ALERT SERVICE BULLETIN

212-20-163

MODEL AFFECTED: 212

SUBJECT: ENGINE OIL CHECK VALVE P/N 209-062-520-001,
INSPECTION AND REPLACEMENT OF.

Figure 1. Engine Oil Check Valves Locations

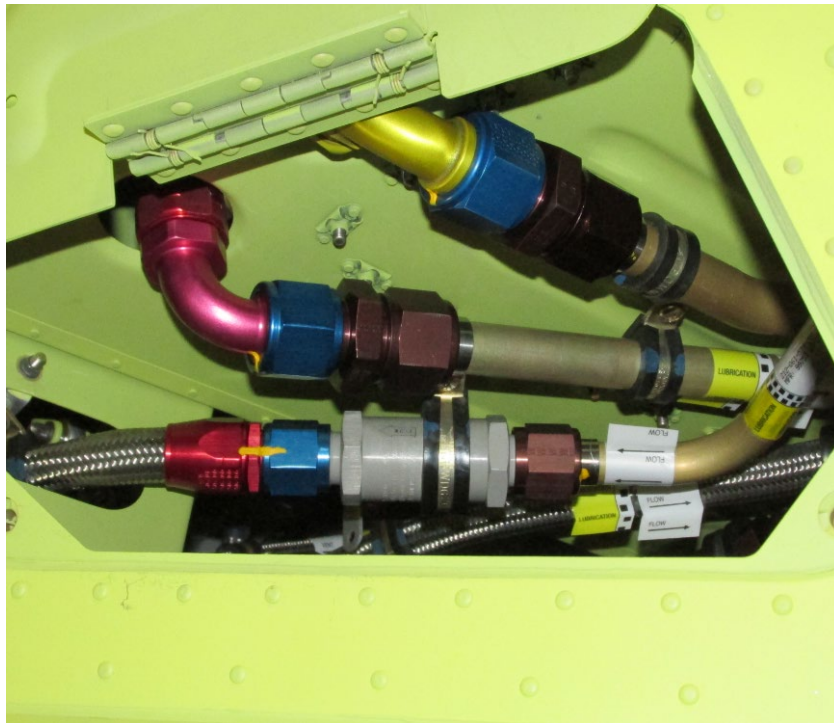
1. Prepare the helicopter for maintenance and gain access to the engine oil check valves. The engine oil check valves are located in the engine reduction gearbox compartment under the oil coolers (Figure 1, Details A and B).

1. Prepare the helicopter for maintenance and gain access to the engine oil check valves (Figure 1, Details A and B).
2. Using a strong light source, visually inspect the oil check valves for general condition and oil leaks. Inspect for cracks at the inlet end where the threaded fitting is installed (Figure 3).
3. If a crack is found, replace the check valve prior to next flight. Figure 4 shows an example of a cracked check valve.
4. If no cracks or any other defects that would cause the valve to be unserviceable are found, make an entry in the helicopter logbook and historical service records

Figure 3. Engine Oil Check Valve Outside Diameter Measurement

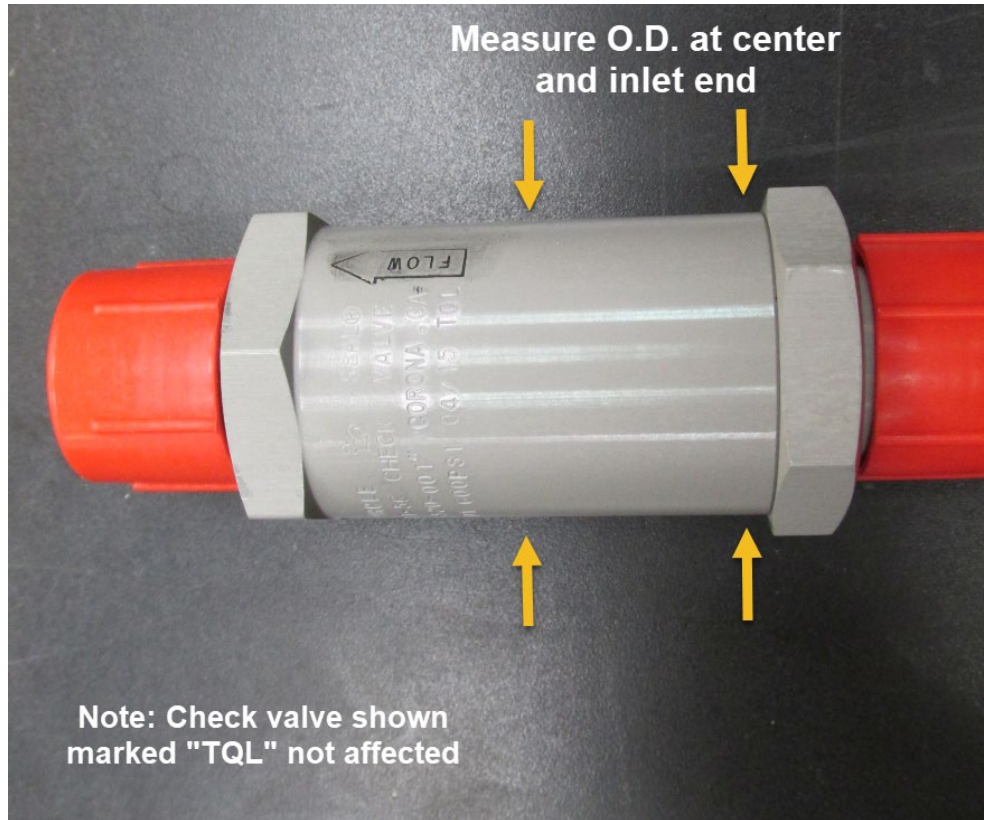
4. If one or both check valves are affected, proceed as follows:
 - a. Using a caliper or equivalent, measure the check valve housing at the center and record dimension (Figure 3).
 - b. Measure the housing at the inlet end where the threaded fitting is installed and record dimension.
 - c. If the dimension measured at the inlet end is no more than 0.003 inch (0.0762 mm) greater than the measurement at the center, the valve is serviceable and does not require further inspection or replacement. Make an entry in the helicopter logbook and historical service records indicating the findings and compliance with this Alert Service Bulletin.

- d. If the dimension measured at the inlet end is greater than 0.003 inch (0.0762 mm) when compared to the measurement at the center, the valve will require replacement. Part III can be accomplished immediately, or Part II can be accomplished until the defective valve can be replaced in accordance with Part III.
- e. If the defective check valve is not replaced immediately, make an entry in the helicopter logbook and historical service records indicating the findings and that Part II must be accomplished every 25 flight hours or 30 days whichever comes first until Part III is accomplished.

Figure 4. Cracked Engine Oil Check Valve

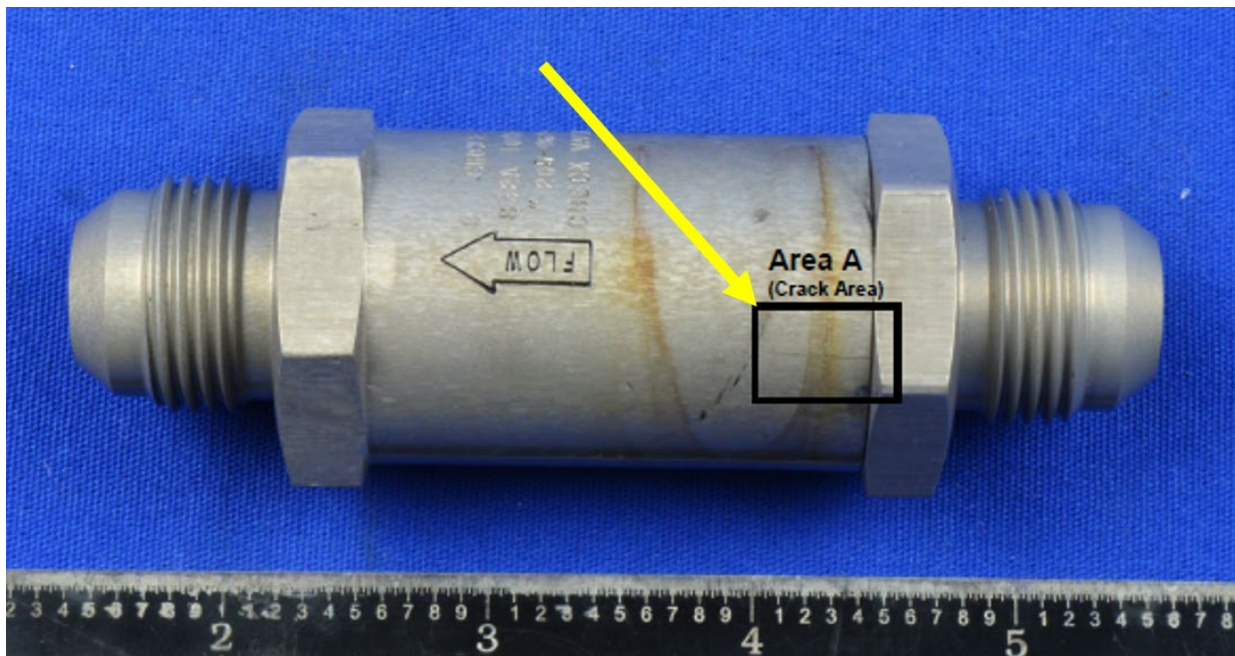
Bell recently received a report of a cracked check valve manufactured by Circor Aerospace (Circle Seal). This check valve was manufactured in 2009 which is outside of the manufacturing date range (October 2011 – March 2015) addressed by the ASB

This recent check valve cracking report indicates that additional oil check valves P/N 209-062-520-001 manufactured by Circor Aerospace (Circle Seal) not having the "TQL" marking may be susceptible to cracking with time in service.
